Project File: **Bella Mesa South Filing 1 (PL26-0011 and RE2026-116)**

Douglas County Addressing has completed an additional review of the Bella Mesa South Filing 1 plat and has the following comments:

BELLA MESA SOUTH FILING NO. 1

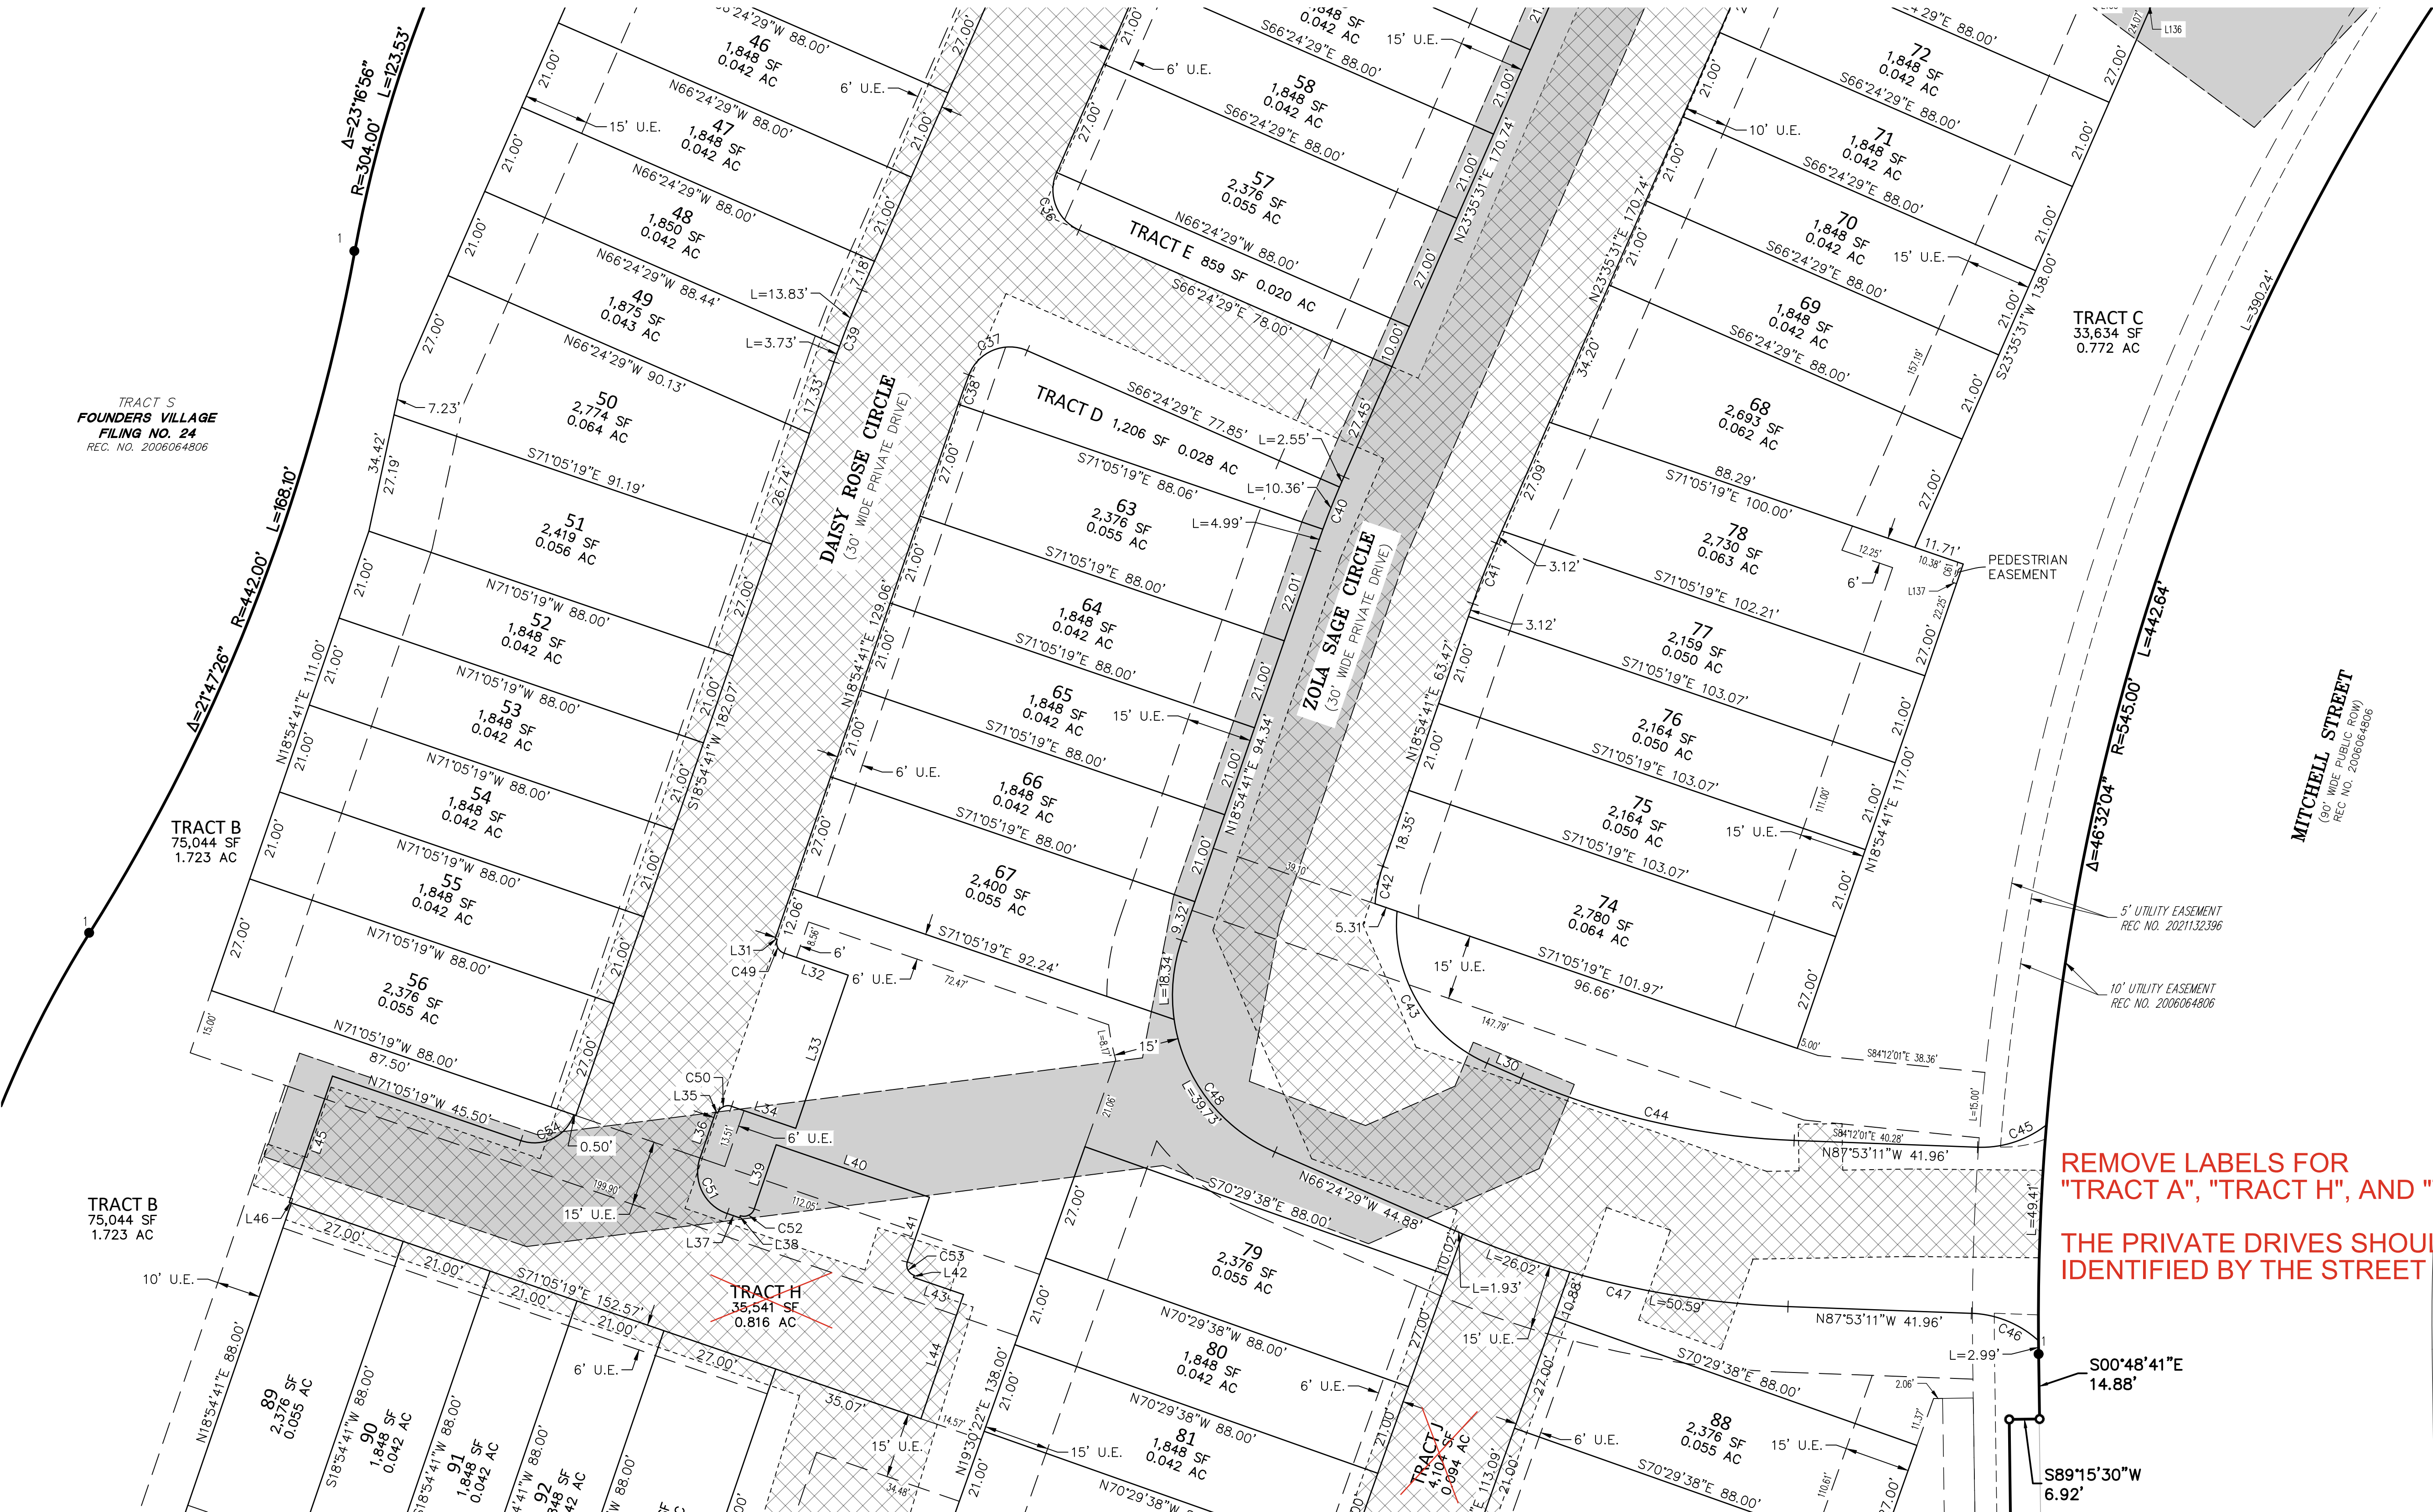
REMOVE LABELS FOR
"TRACT A", "TRACT H", AND "TRACT J".
THE PRIVATE DRIVES SHOULD BE
IDENTIFIED BY THE STREET NAME ONLY.

DETAIL SHEET
PROJECT NO.: PL26-0011
BELLA MESA SOUTH FILING NO. PLAT SHEET 6 OF 8

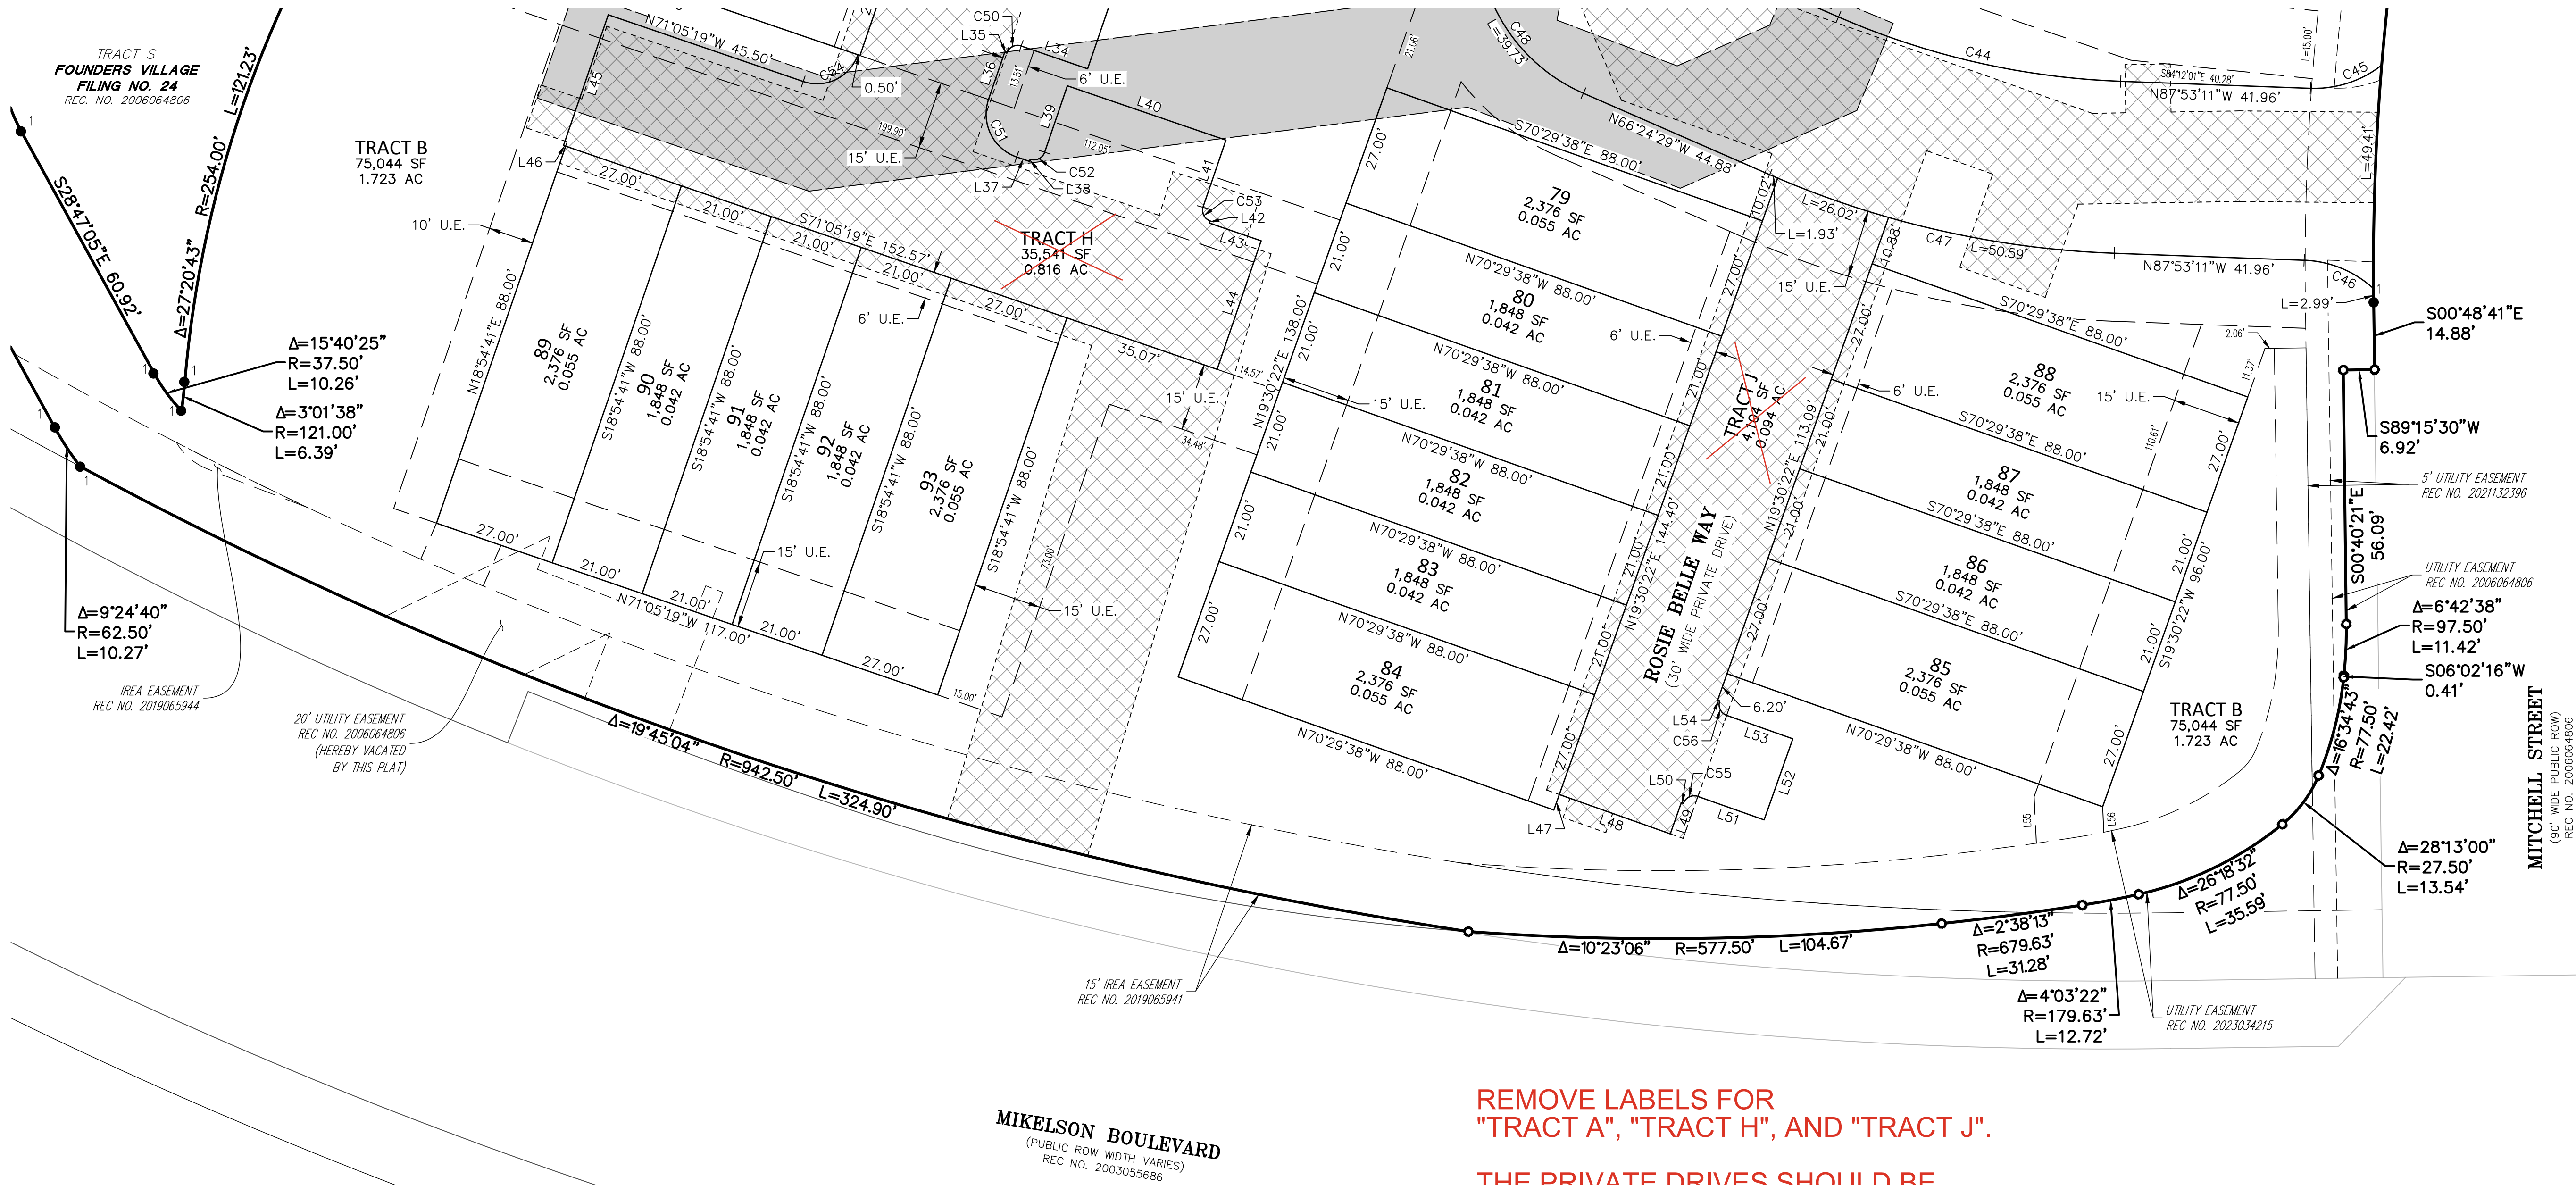
REMOVE LABELS FOR
"TRACT A", "TRACT H", AND "TRACT J".

THE PRIVATE DRIVES SHOULD BE
IDENTIFIED BY THE STREET NAME ONLY.
